# Conceptual Review Agenda

Schedule for 09/12/16 to 09/12/16

# 728 Cherry St. Duplex

**Description of project:** This is a request to add a second dwelling unit to the existing home at 728 Cherry St. (parcel #9711219025). The new 1,040 sq. ft. unit would be constructed behind the existing home and connected with a breezeway. The existing home will remain unchanged as part of this development. The site is located in the Neighborhood Conservation – Medium Density (NCM) zone district. This proposal will be subject to Planning & Zoning Board (Type II) review.

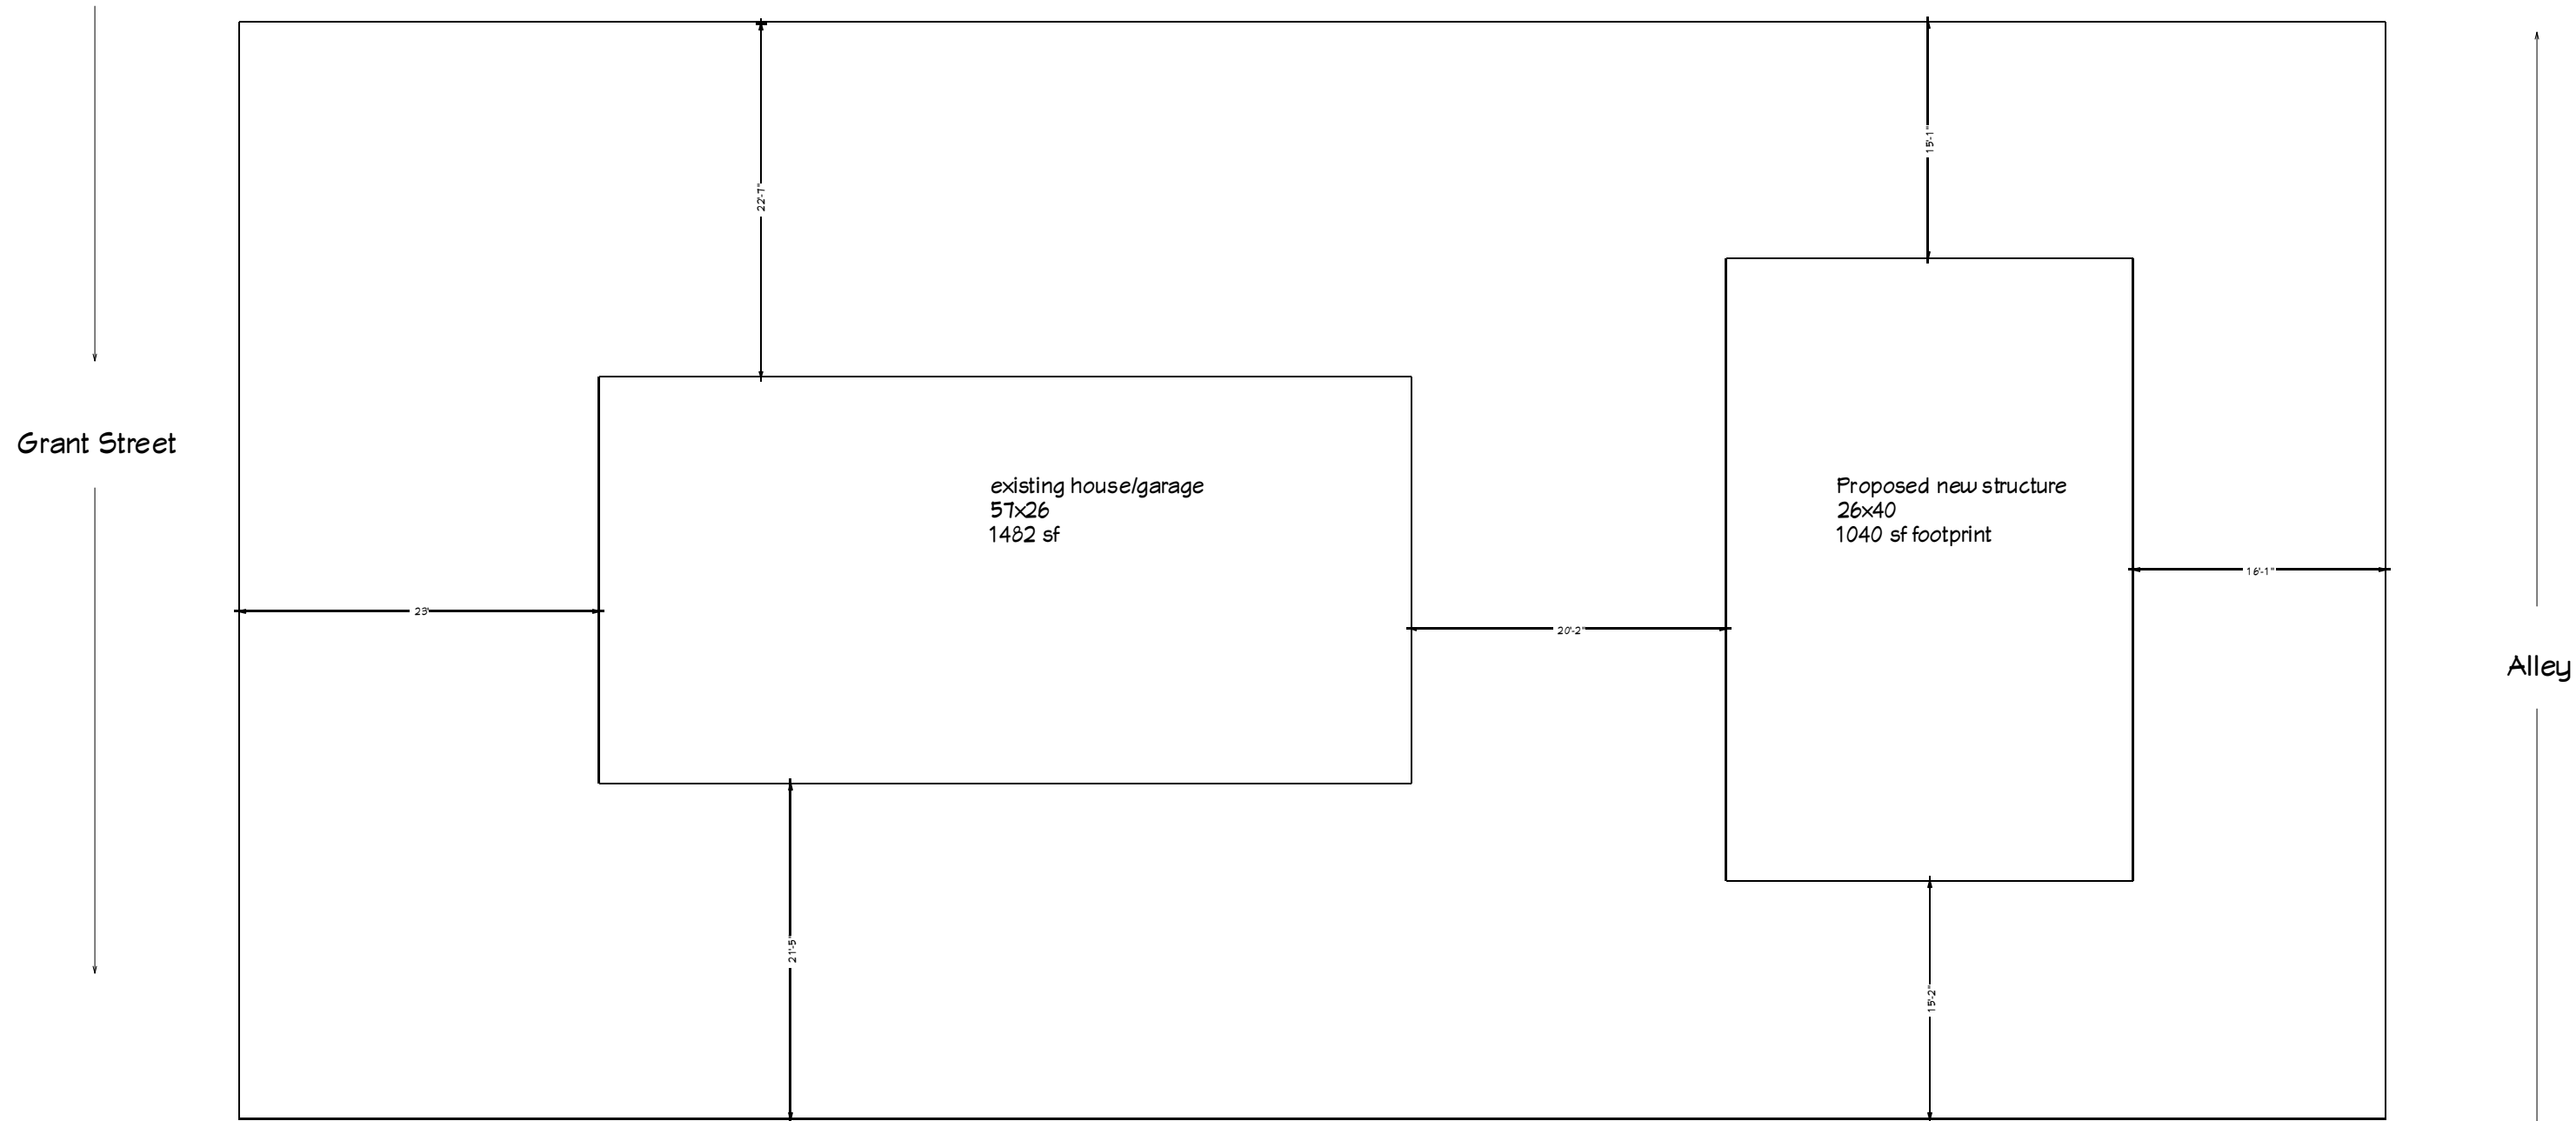
1. As these home is more than 50 years of age, it will need to be reviewed for potential Landmark eligibility. The historic review process requires good quality photographs of all sides of all buildings and structures, a description of the work proposed for the buildings, and a signed owner sheet. The review takes no longer than 2 weeks, after which the results may be appealed by any citizen for a two-week period. If there is no appeal, then the results stand for five years.
2. If the proposed project is subject to the requirements in Chapter 3 of the Land Use Code, the project will be reviewed for compliance with LUC Section 3.4.7, historical and cultural resources.

**EXISTING 830 EAST MYRTLE - SOUTH ELEVATION**

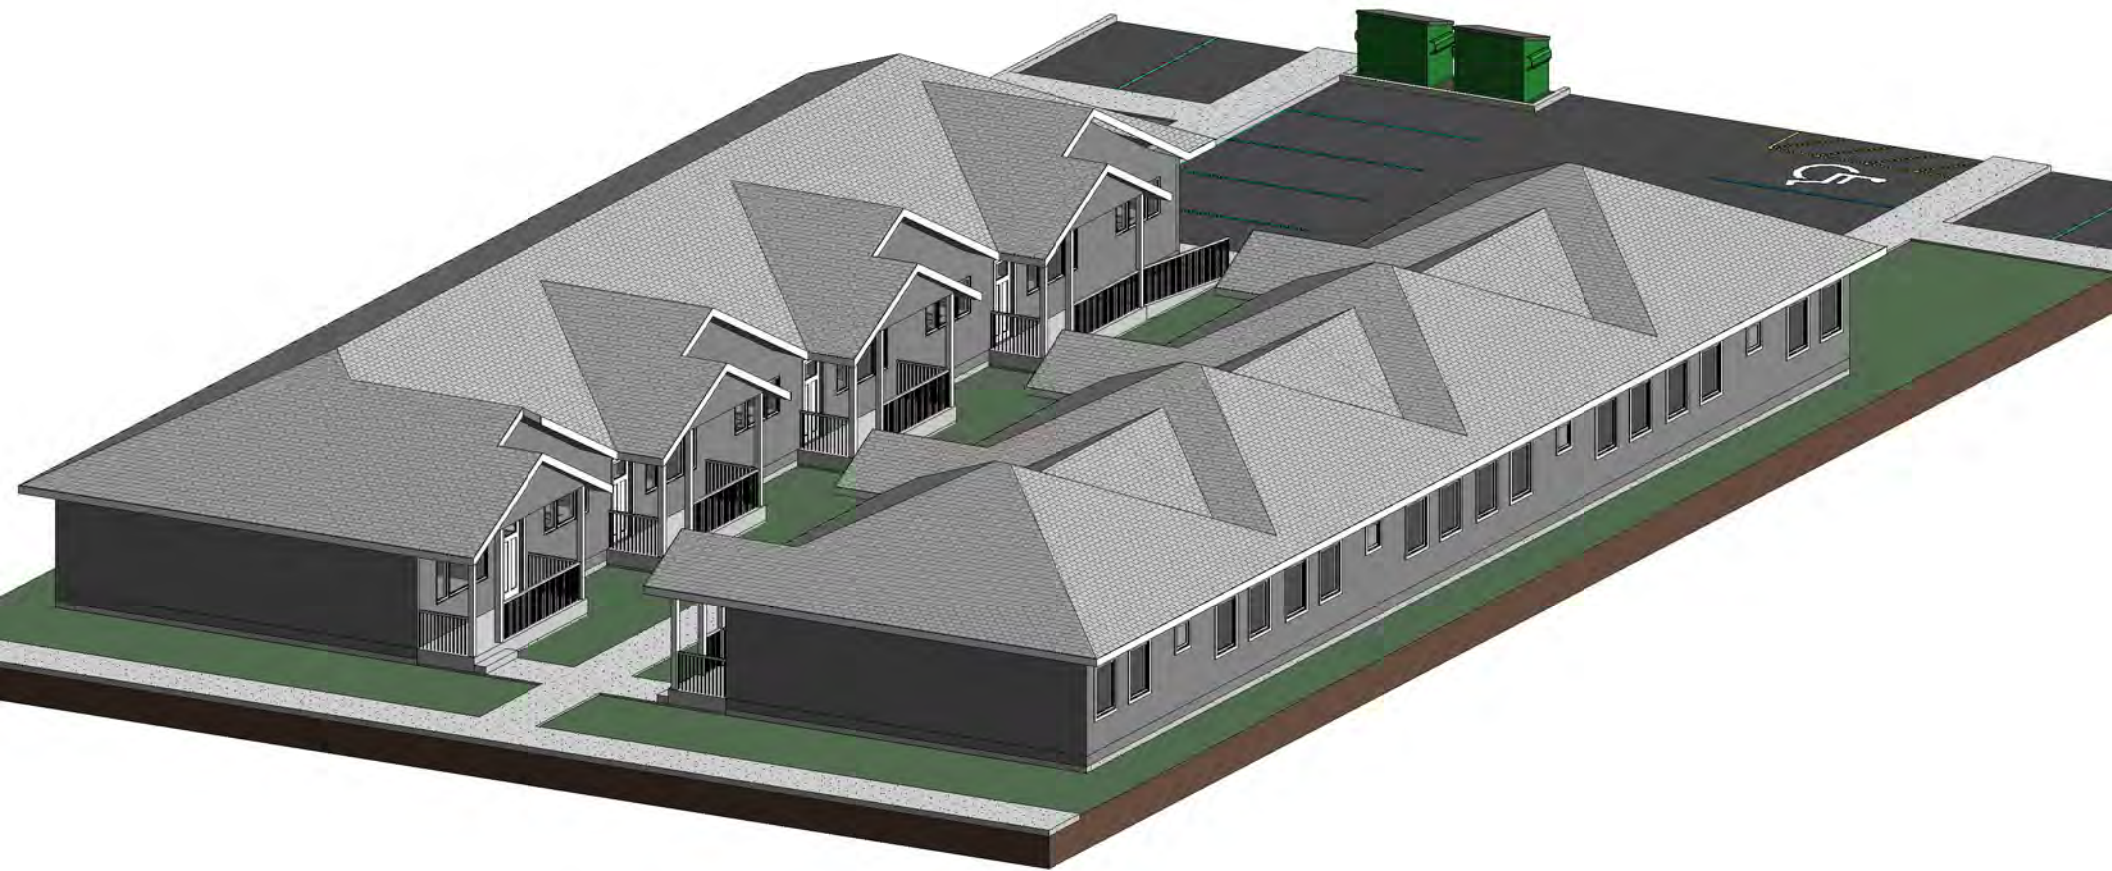
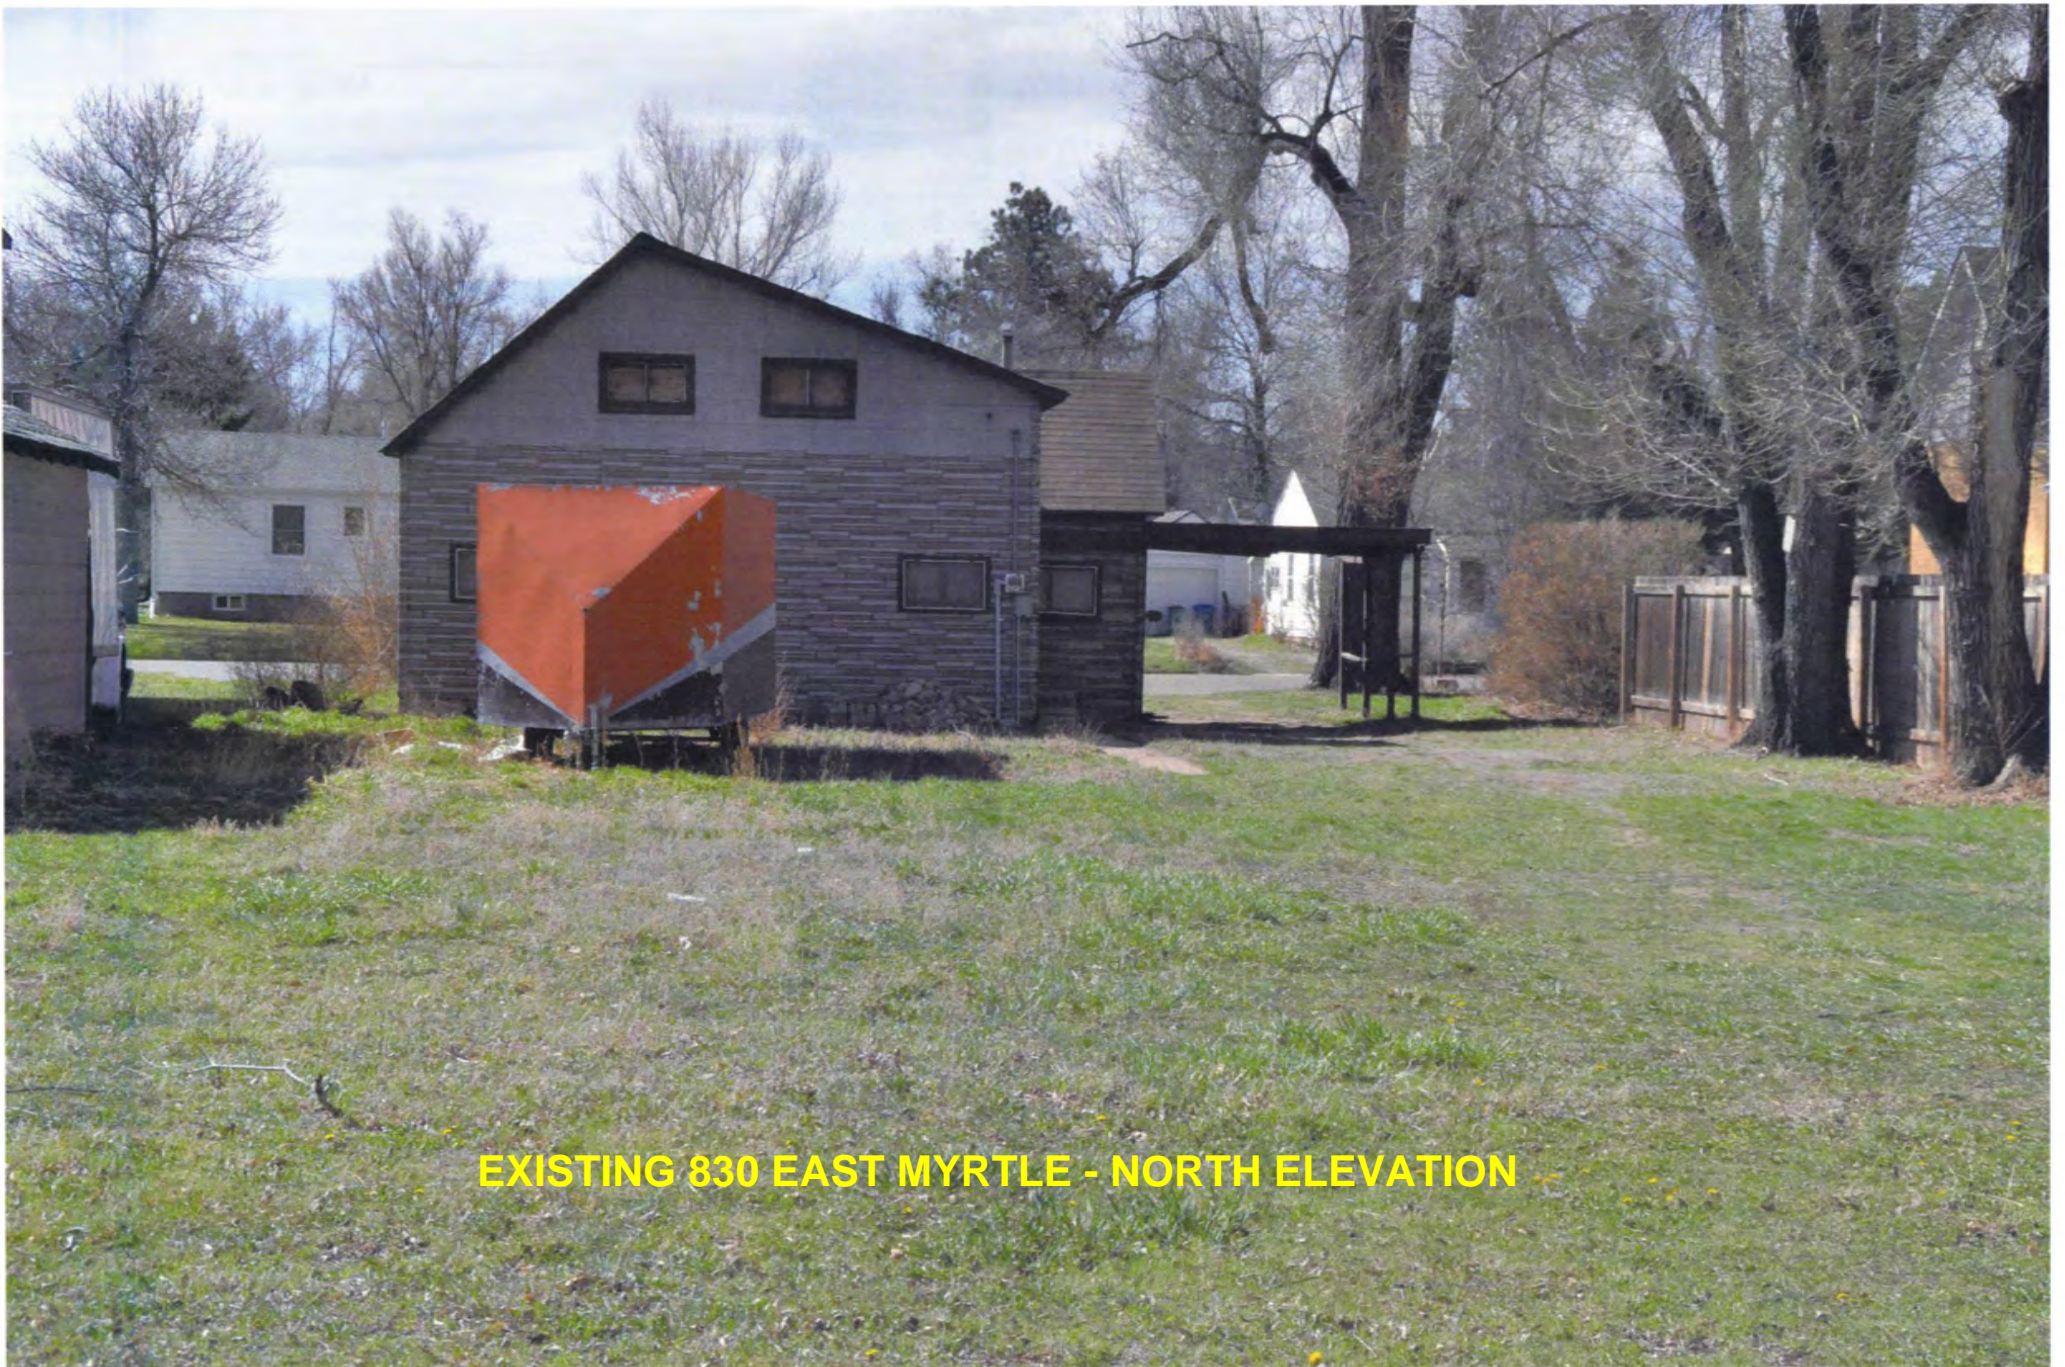
1. As these homes are more than 50 years of age, both will need to be reviewed for potential Landmark eligibility. The historic review process requires good quality photographs of all sides of all buildings and structures, a description of the work proposed for the two buildings, and a signed owner sheet. The review takes two weeks, after which the results may be appealed by any citizen for a two-week period. If there is no appeal, then the results stand for five years.
2. If the proposed project is subject to the requirements in Chapter 3 of the Land Use Code, the project will be reviewed for compliance with LUC Section 3.4.7, historical and cultural resources.
